17 February 2023

**Subject: “Secretary of the Interior’s Standards” (SOI)
Consistency Review for 515 B Street, Petaluma,
CA 94952 (APN 008-103-003-000)**

Proposed South Elevation and New Garage

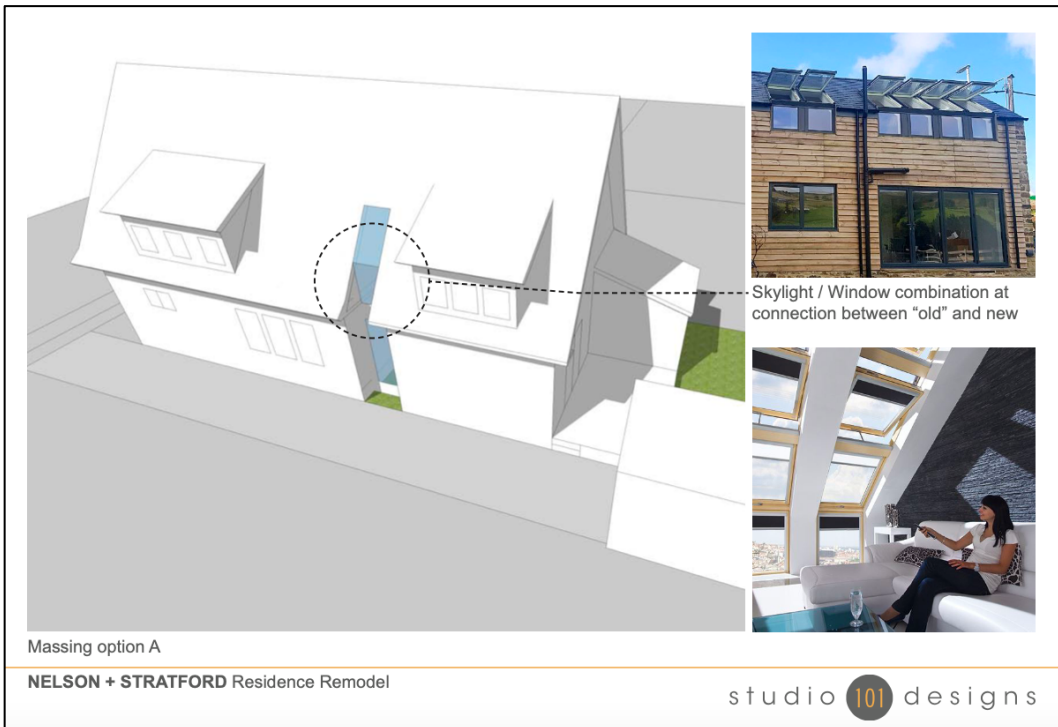
8. New additions and adjacent or related new construction will be undertaken in such a manner that, if removed in the future, the essential form and integrity of the historic property and its environment would be unimpaired.	CONSISTENT The proposed additions on the rear of the house impact sections of the building that have been modified by previous construction projects. They would be minimally visible from the public right-of-way and would have no visual impact on the historic fabric of the surrounding historic district. The additions could be removed at a future date with no impact to the form and integrity of the historic main block.

9. New additions, exterior alterations, or related new construction will not destroy historic materials, features, and spatial relationships that characterize the property. The new work will be differentiated from the old and will be compatible with the historic materials, features, size, scale and proportion, and massing to protect the integrity of the property and its environment.	CONSISTENT The proposed additions on the rear of the house would be differentiated from the historic main block by a lightwell that would serve as a “hyphen” and a visual break between the two sections of the building. The new additions would be compatible with the historic main block in massing, scale, roof, color, materials and details.

Proposed South elevation, indicating lightwell that would replace 1998 infill; new wings to the right of lightwell
